**Re: Planning Application 2018/2004/P - Public House 4 Conway Street, W1T 6BB**  
**Restated Objection to the Application as proposed.**

Further to our letter of 11 August 2018 and in the light of the Applicant's responses and reissue of its Noise Impact Assessment P18-171-R01v3 (the acoustic report) we would restate our objection to the Application as set out below.

3175/36 B

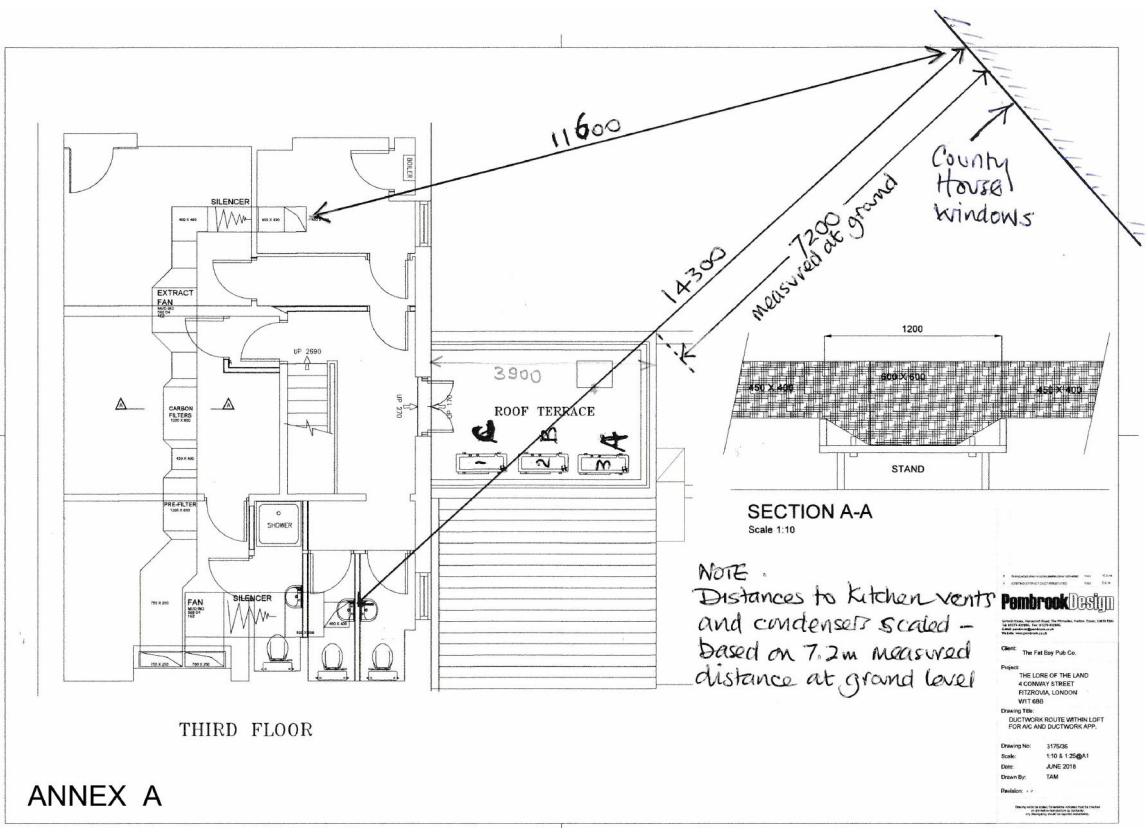
6. We submit that these distances are inaccurate. We have measured the distance on the ground between the nearest corner of the roof terrace (the proposed location of the condensers) and the line of our windows. This is 7.2 metres by tape measure. We have measured the length of the roof terrace as 3.9 metres. Using these measurements we have marked-up the Applicant's drawing 3175/36B (see Annex A) and calculated the distances to each of the 6 items of equipment.

7. These distances are reduced by 1 metre in the noise attenuation calculations in order to predict the attenuation at 1 metre from the window, in accordance with the Camden Local Plan 2017 Appendix 3 Noise Thresholds.

SECTION THROUGH SOUND PATH FROM SOURCE (CONDENSER C) ON TERRACE/ROOF

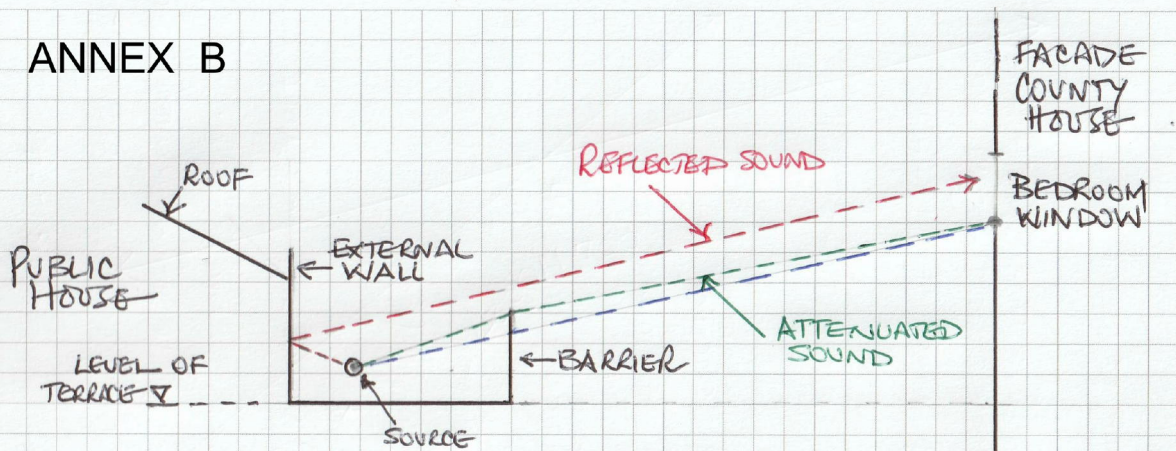
8. The condensers are located in front of a brick external wall. Therefore, as the noise source is not free field condition our corrected analysis includes 3dB to account for a reflecting plane behind this equipment. Annex B shows a typical section which demonstrates this.

10. The acoustic report includes, on the last page, a barrier calculation which arrives at an attenuation values for the condensers. The calculation places the noise source at the finished roof level. This is not correct as the height of the condensers is 990mm. The acoustic report also recommends (paragraph 4.11) that the equipment be mounted on vibration isolation mounts. We submit that 600mm should be used as the height of the noise source above finished roof level. We have recalculated the barrier attenuation for each condenser, using the data shown in Annex B. Our attenuation results are included in the noise calculations in Annex C.
